**Revised OICA comments (superseding WP29-153-02)
to ECE/TRANS/WP.29/2011/48**

**Proposal for guidelines on the scope, administrative provisions
and alternative requirements in Regulations annexed
to the 1958 Agreement**

Figure 1
Illustration of a transitional period for a vehicle or vehicle systems Regulation

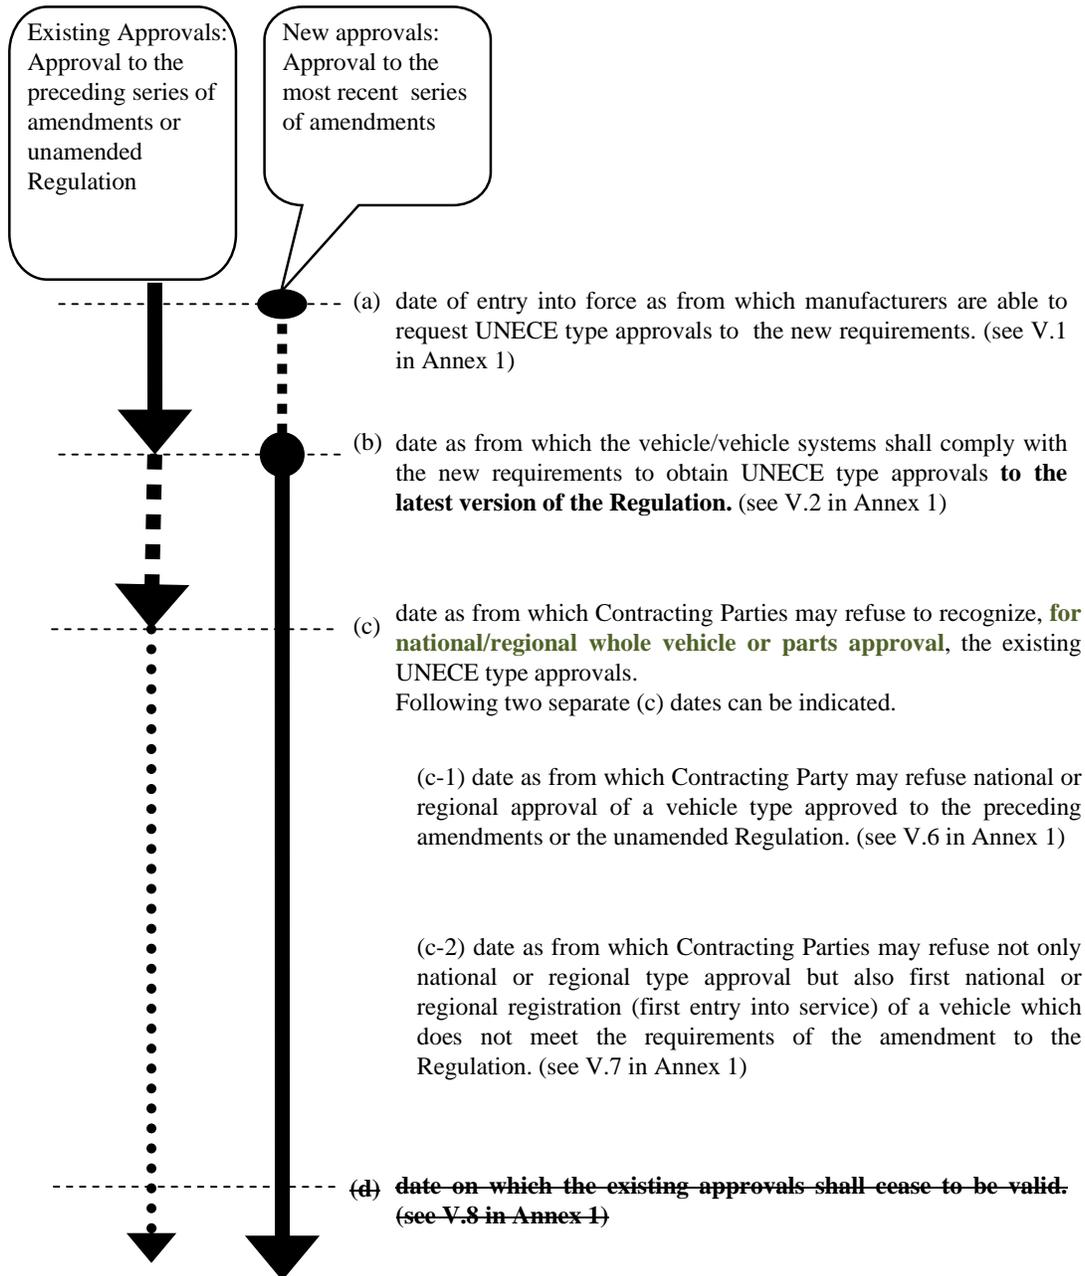
~~If date (d) is not written in the transitional provisions, the e~~Existing approvals ~~can~~ remain valid, but Contracting Parties are not obliged to accept them as from date (c).
